**DAVID PLUMMER & ASSOCIATES**

June 3, 2015

**Re: Mediterranean Village Review - #14153**  
**Traffic Impact Study, Parking Analysis & Valet Operations Analysis**

HOTEL DROP-OFF - OPTION #3 “STAFF RECOMMENDATION”

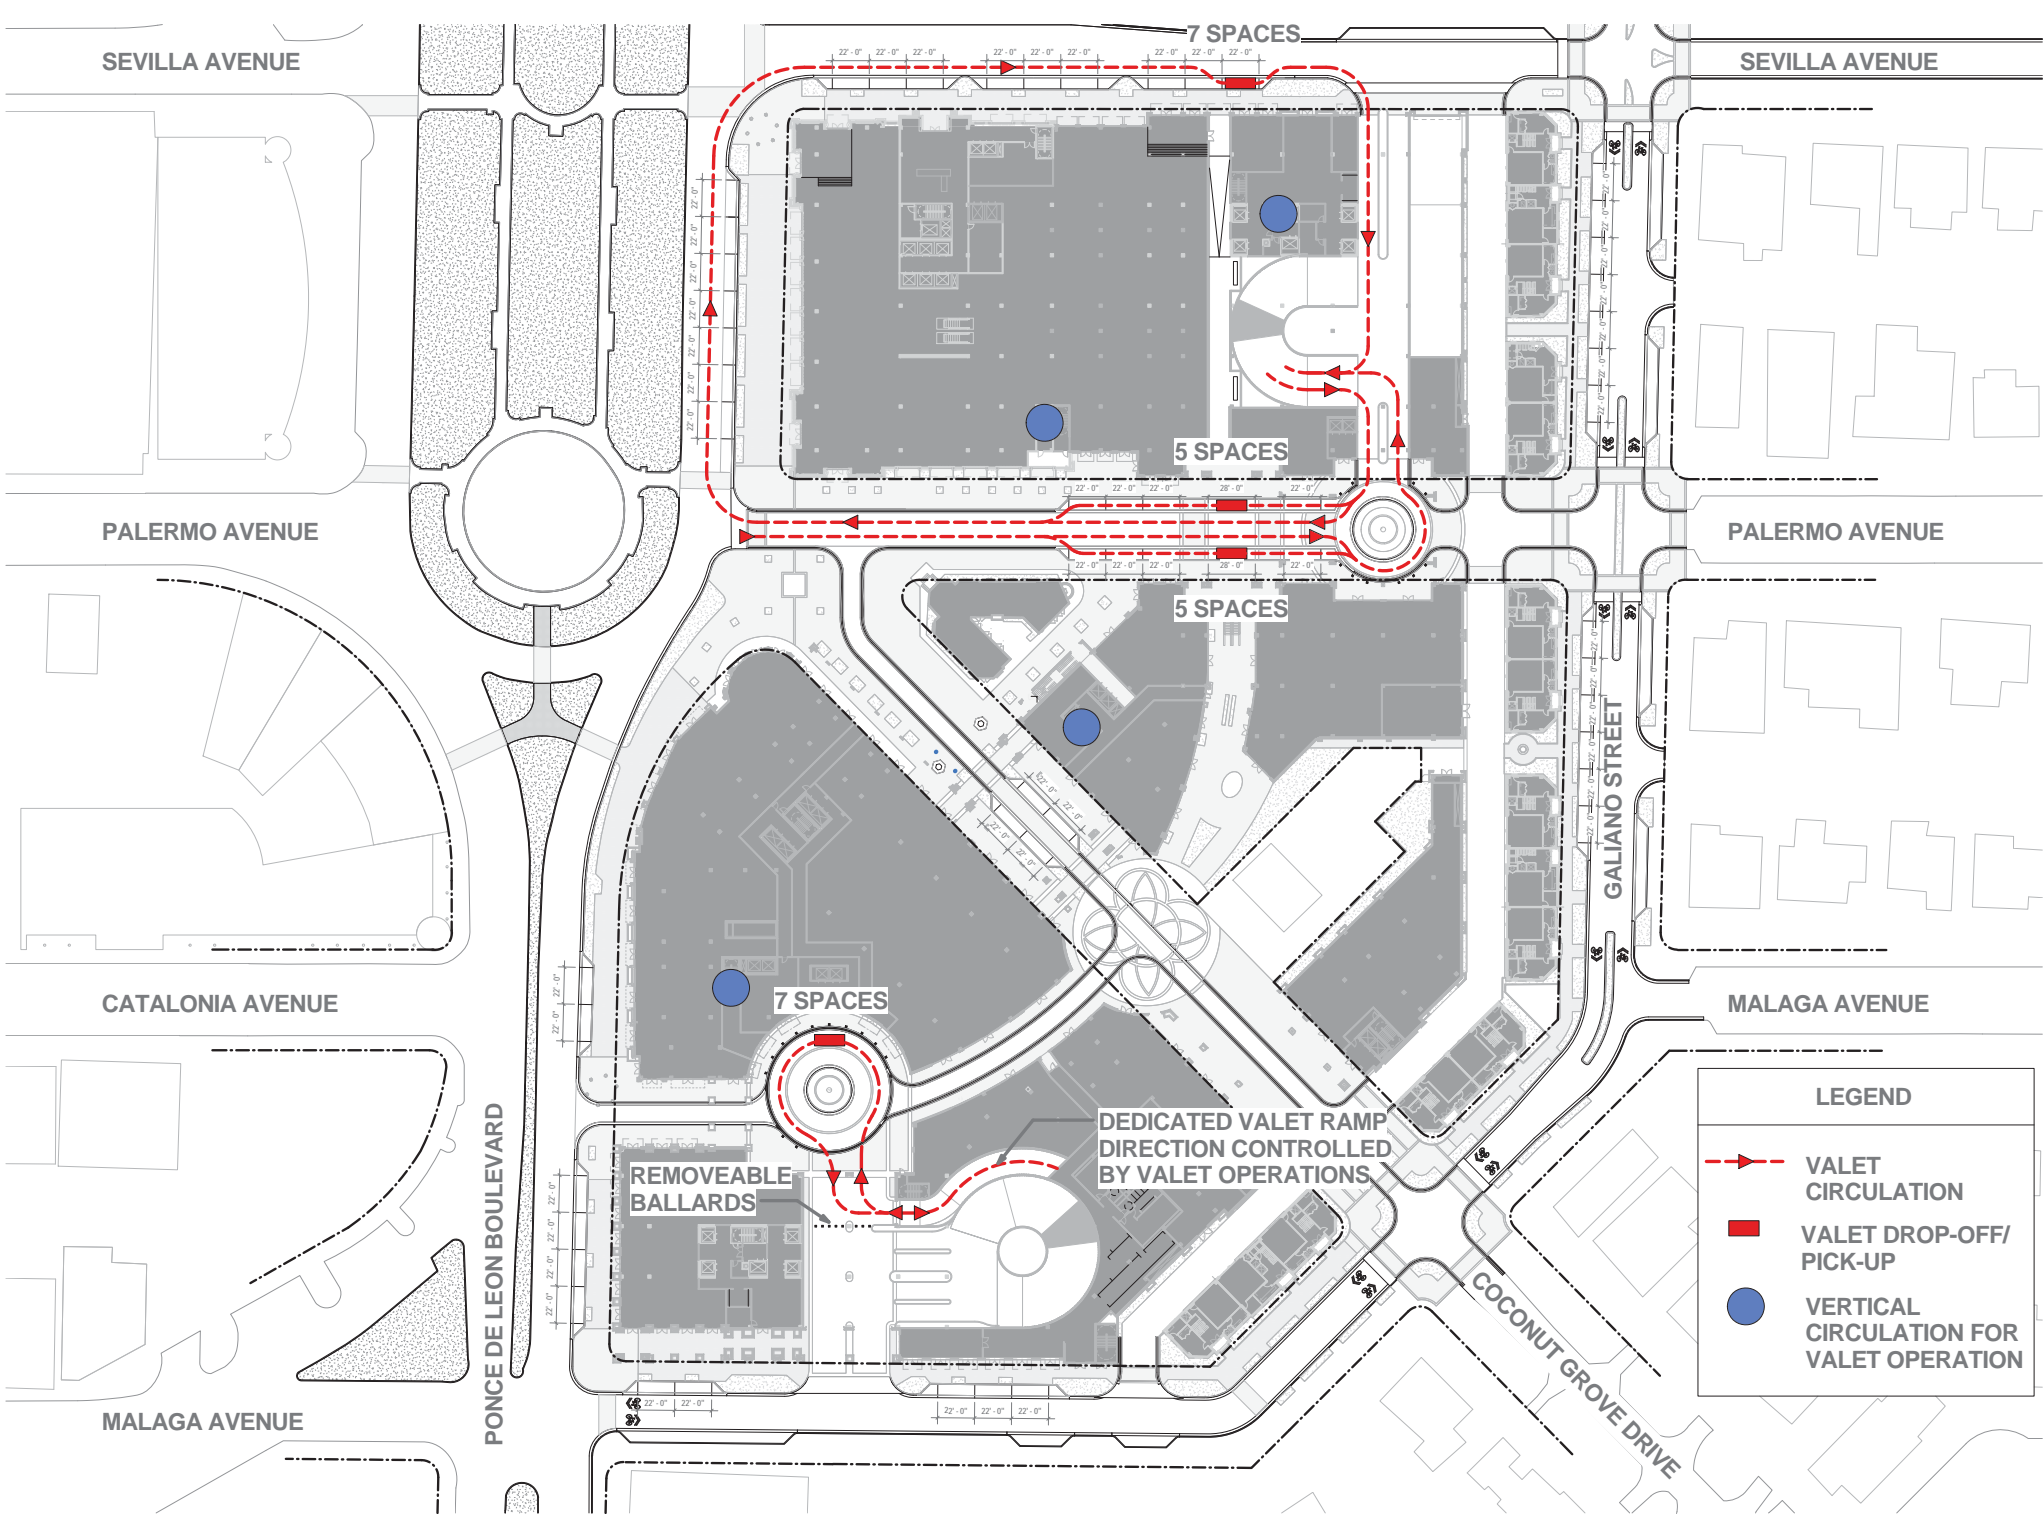
During first reading, the project included direct access to the hotel from Ponce. This access plan for the hotel was acceptable. The project has since changed to address comments from the Commission. Of the newly proposed options, Option 3 is an acceptable alternative and preferable to Option 2 provided that the following conditions are included: 1) the hotel valet ramps will be completely segregated from the Malaga driveway ramping system and no traffic from Malaga would be allowed to access the hotel's porte cochere, and 2) two one-way ramps (similar to the Ponce alternative) or a two-way, two-lane ramp for hotel valet use only is provided. See attachments for hotel access options.
